SILVERTOWN TUNNEL

7.4 Design Principles

TR010021

Revision ~~1~~0

Figure 1-1 Design Process

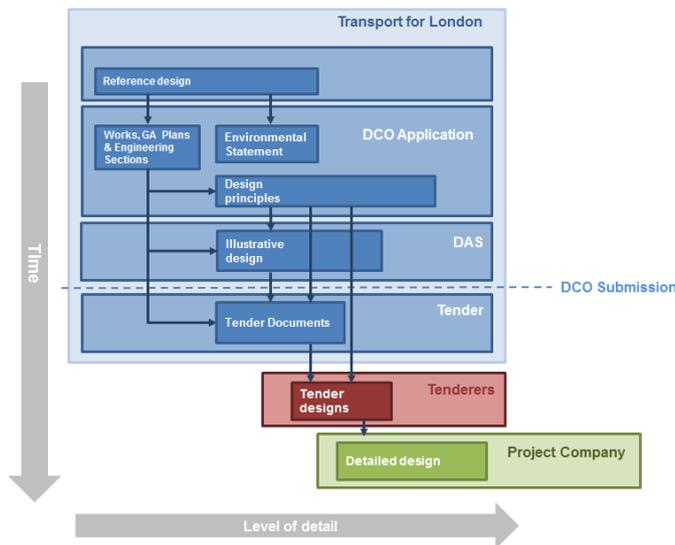
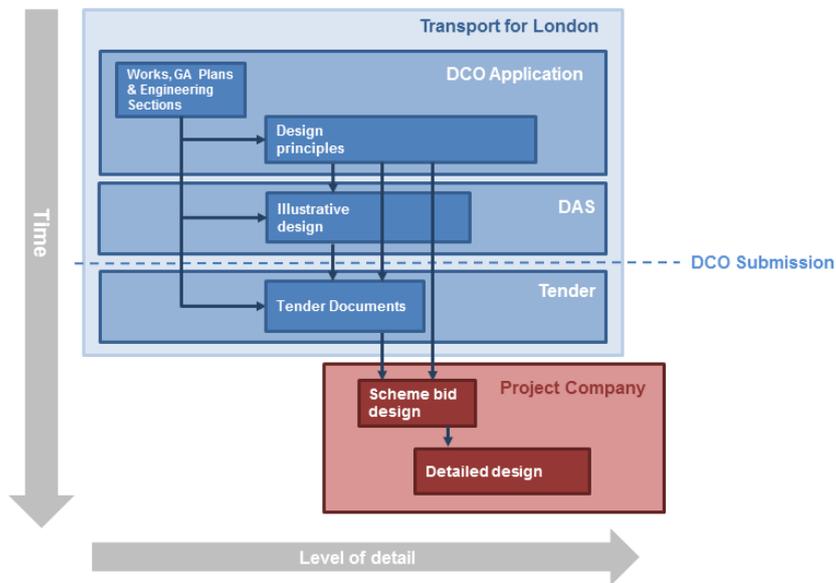
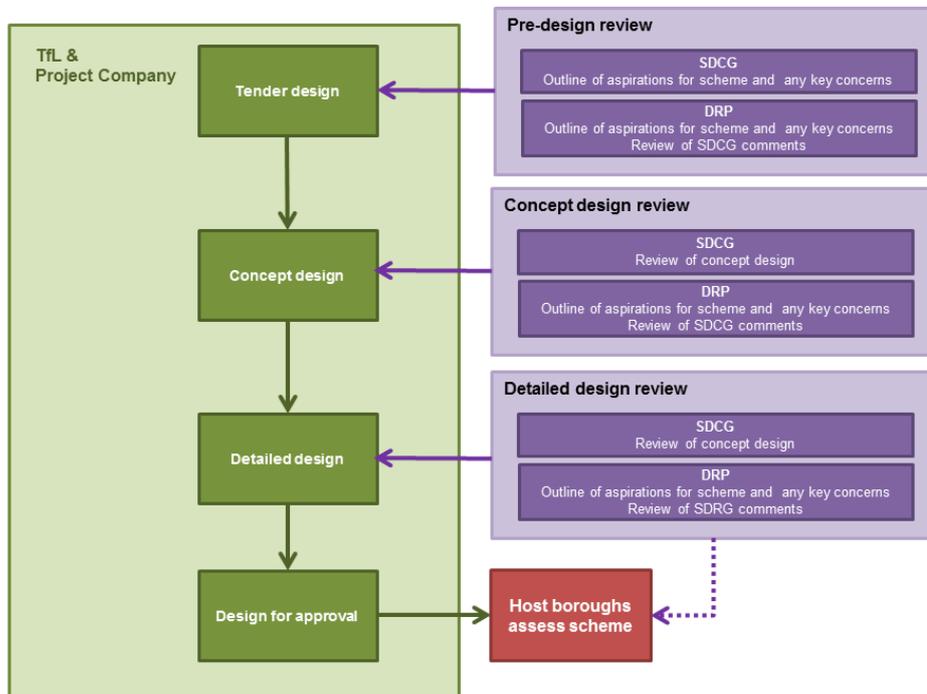
- 1.2.4 [Each of the above elements sits within the design process as shown in Figure 1-1.](#)

~~4.2.51.2.6~~ Each of The Design Review Panel and Stakeholder Design Consultation Group will be consulted as a minimum at the above elements sits within points in the design process as shown in Figure 1-1, Figure 1-2.
